Service Bulletin Computer Monitors

Model: CPD-200ES No. 197

Subject: CRT Socket J001 Label Incorrect Date: June 1, 1998

J001 CRT Socket Focus Leads on the A Board

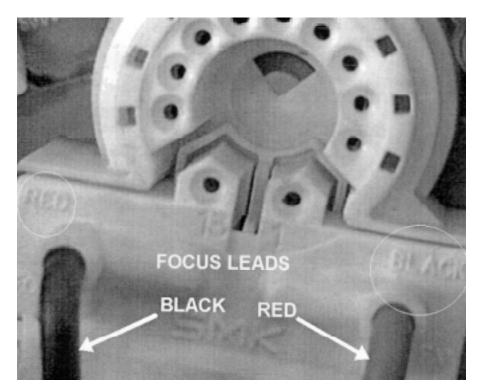
(116C) The imprinted labels for the focus lead colors on J001 on the A Board are incorrect.

The Red colored Focus Lead from the FBT is connected at the J001 input marked "BLACK". The Black colored Focus Lead from the FBT is connected at the J001

input marked "RED". Refer to illustration below.

Solution: Please note the following when the FBT, J001, or the A Board are replaced. The correct Focus Lead connection is with the wire jacket colors reversed from the

imprinted labels on the J001 CRT Socket. Refer to illustration below.
